South Texas Project
Units 1 and 2
Docket Nos. STN 50-498, STN 50-499
Responses to DSER/FSAR Items Regarding Question 430.16N

Question 430.16N

ONSITE DISTRIBUTION SYSTEM CRITICAL PATH COORDINATION - PHASE TIME CURRENT (SH. 1 OF 2)

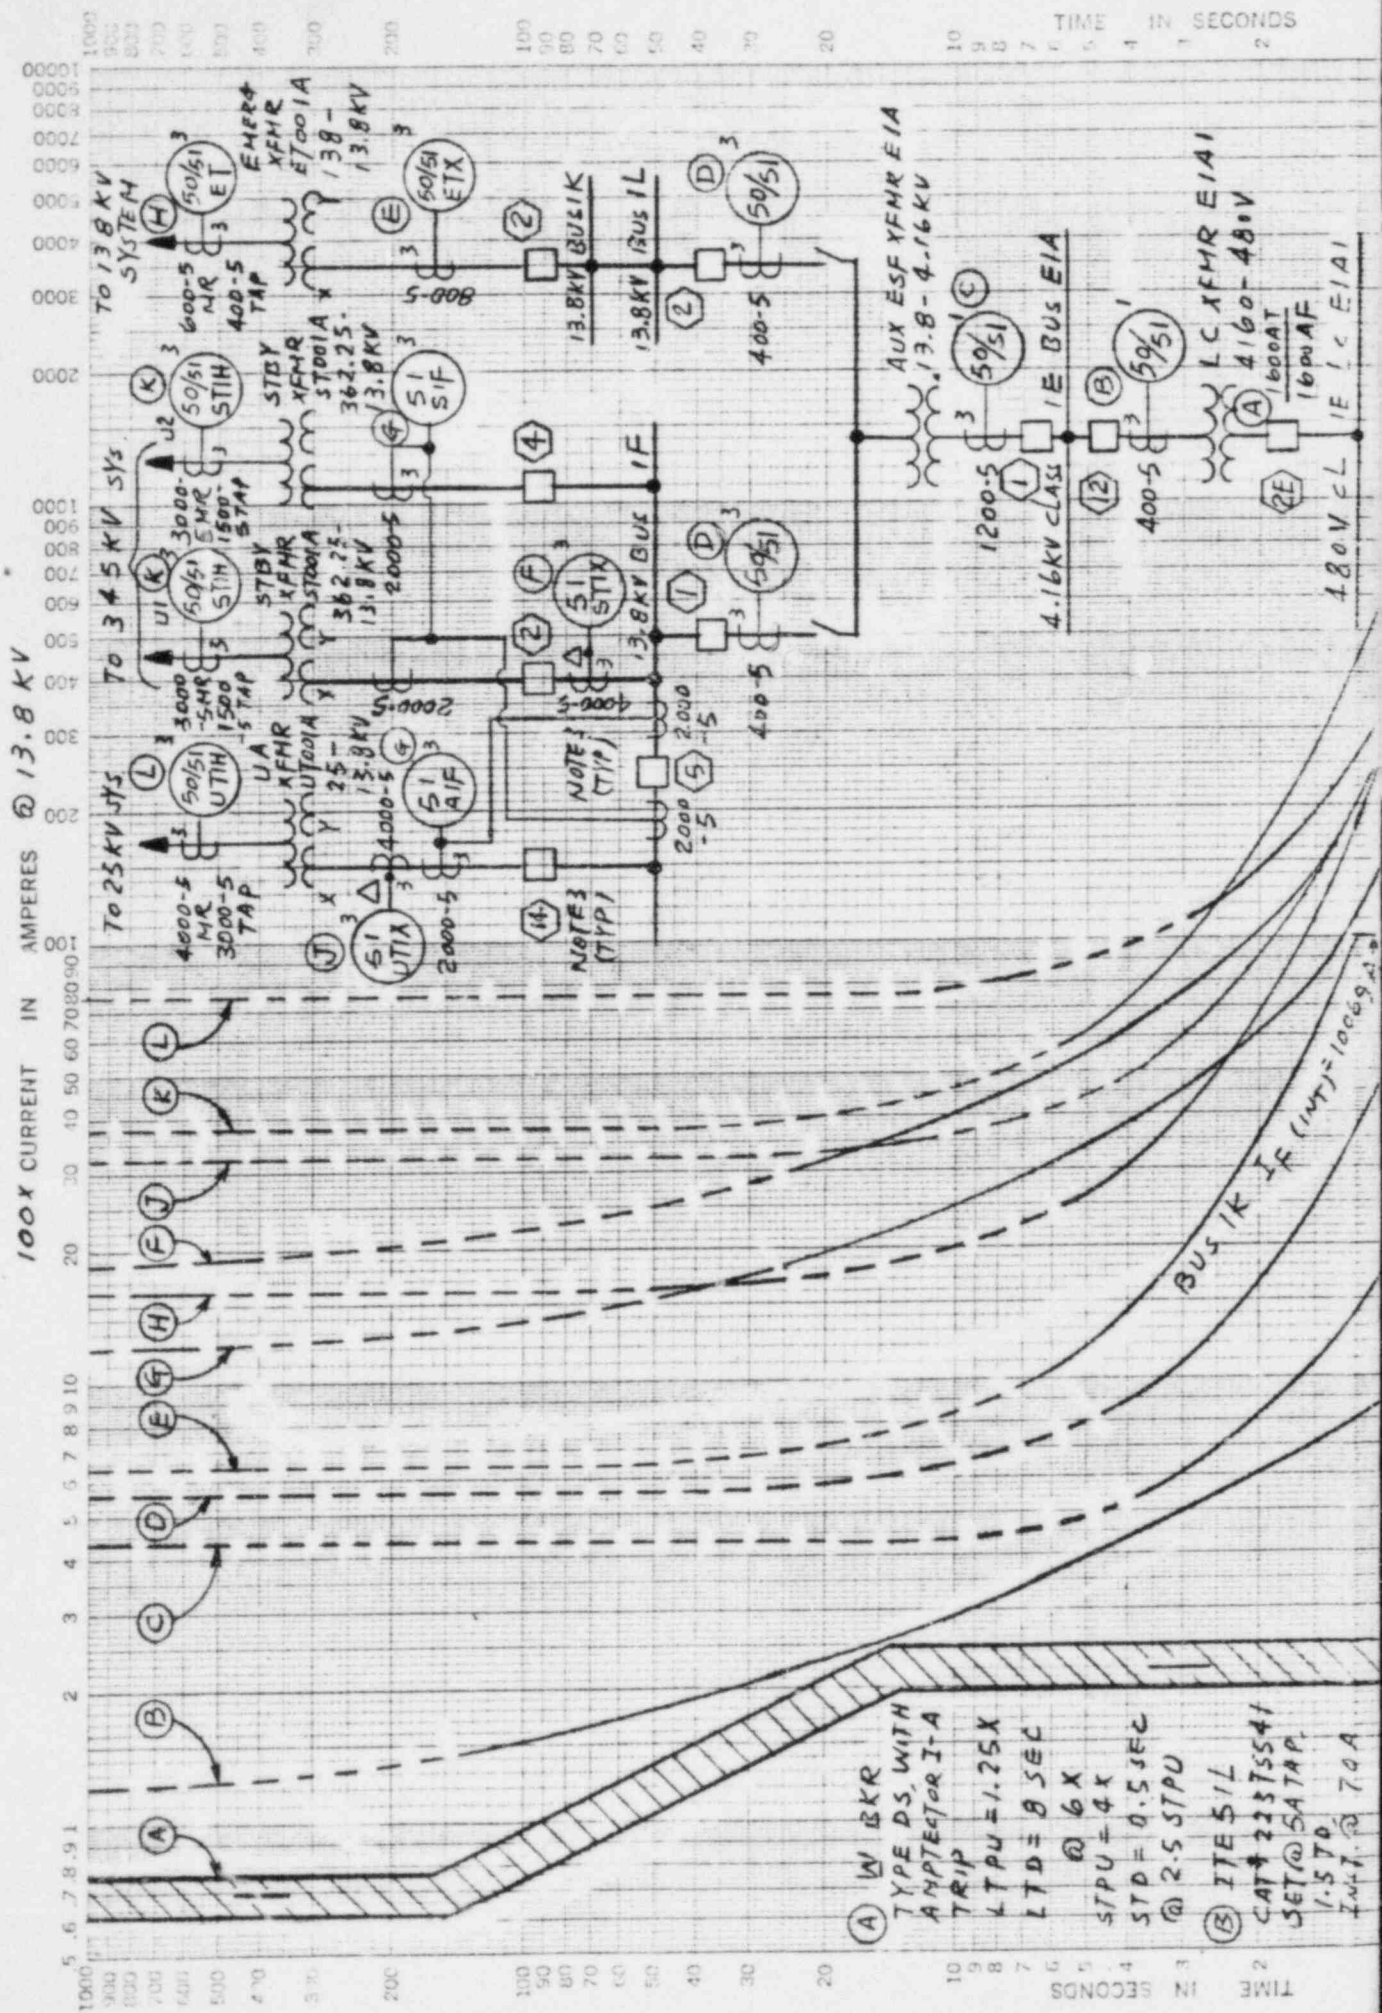
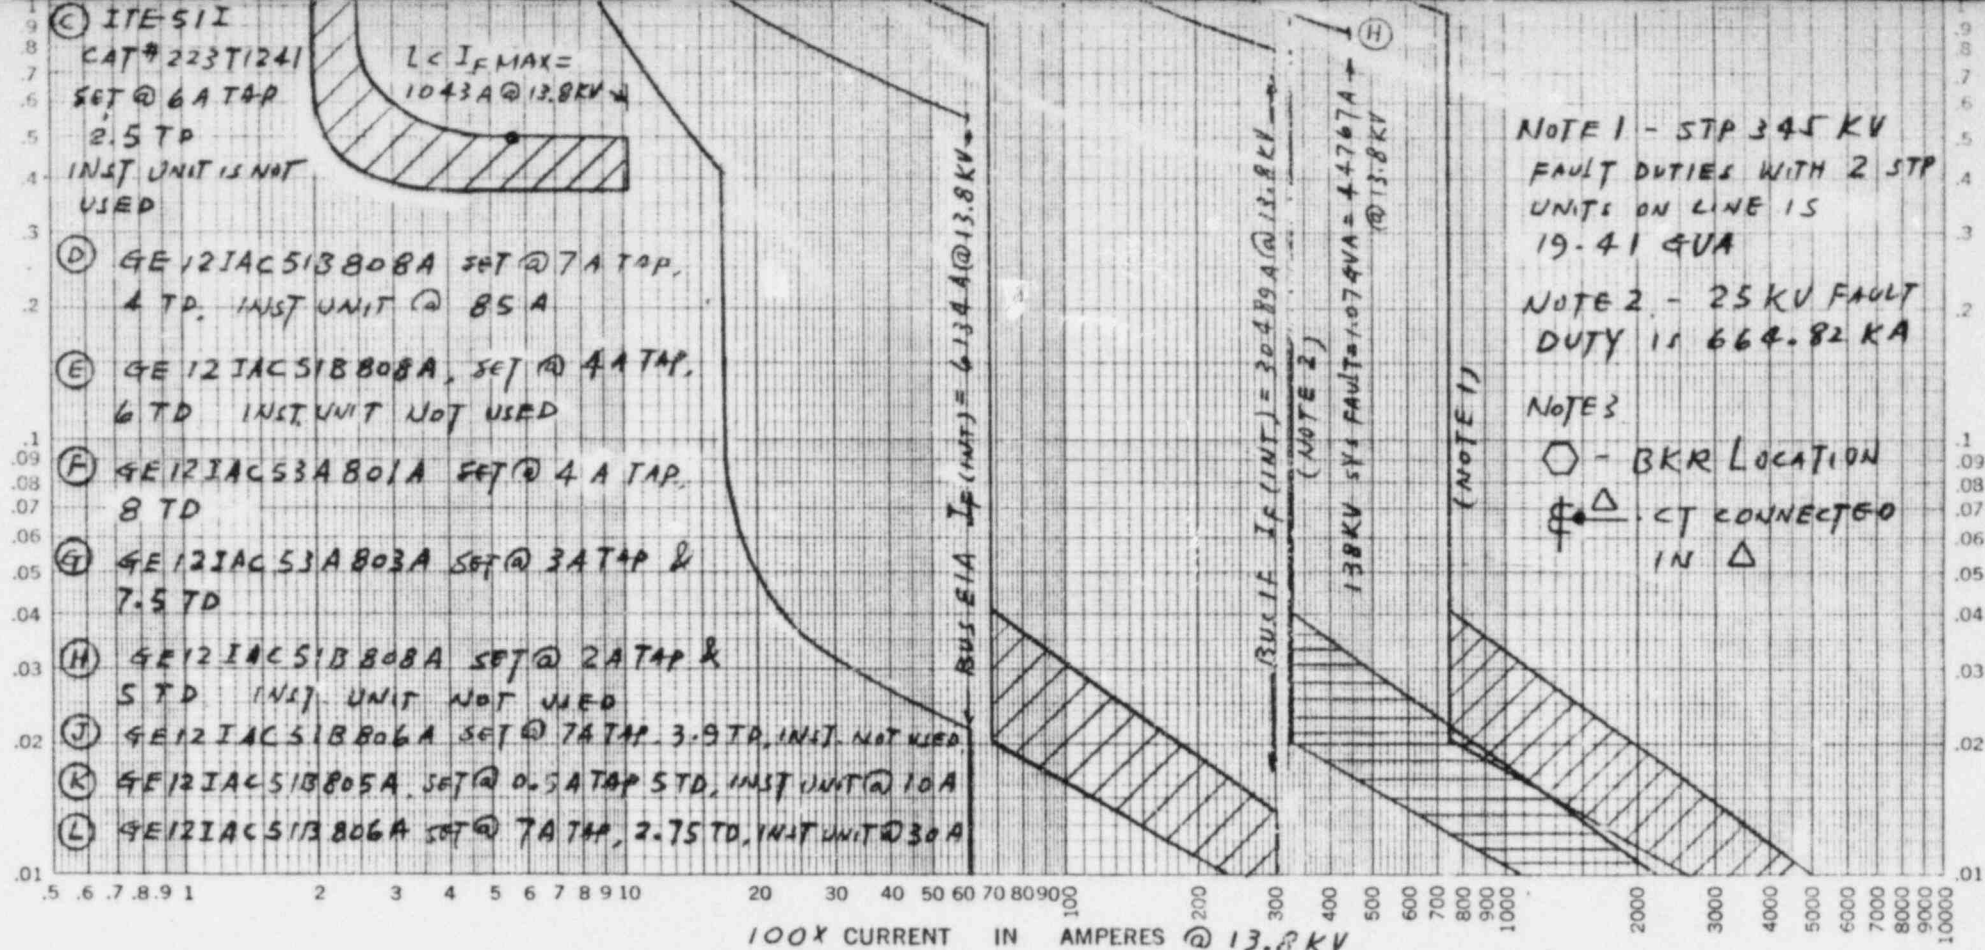
In section 8.3.1 you discuss the onsite distribution system. Your discussion provides insufficient detail for evaluation. Specifically address breaker coordination and the interrupting capacities of switchgear, load centers, motor control centers, and distribution panels under maximum short circuit conditions. Provide this information including supporting drawings and amend your FSAR accordingly.

Interrupting capacities of 13.8 kV and 4.16 kV switchgear are provided in Sections 8.3.1.1.1 and 8.3.1.1.4.1, respectively. Interrupting capacities of 480 V switchgear are selected appropriately, based on the fault current contribution from loads and the source at a bus. Criteria for breaker coordination for onsite power system is discussed in Section 8.3.1.1.4.6. The 13.8 kV and the 4.16 kV detailed design documents are presently available for review. The 480 V detailed design documents will be available after the third quarter of 1985.

Maximum short circuit conditions have been calculated conservatively, by assuming the ultimate system contribution of 30 GVA (the system contribution with the two STP units on line, and with the eight transmission circuits will be 19.41 GVA) and maximum load fault current contribution (motors ≥ 50 HP and with standby diesel generator during testing). The calculations will be updated with final data.

The present calculations indicate that the interrupting capacities of the equipment identified below is not exceeded under worst-case short circuit conditions, with the exception of two out of four 13.8 kV switchgear which yield a negligible, yet negative interrupting capacity margin of 0.2 percent. The present calculations are acceptable
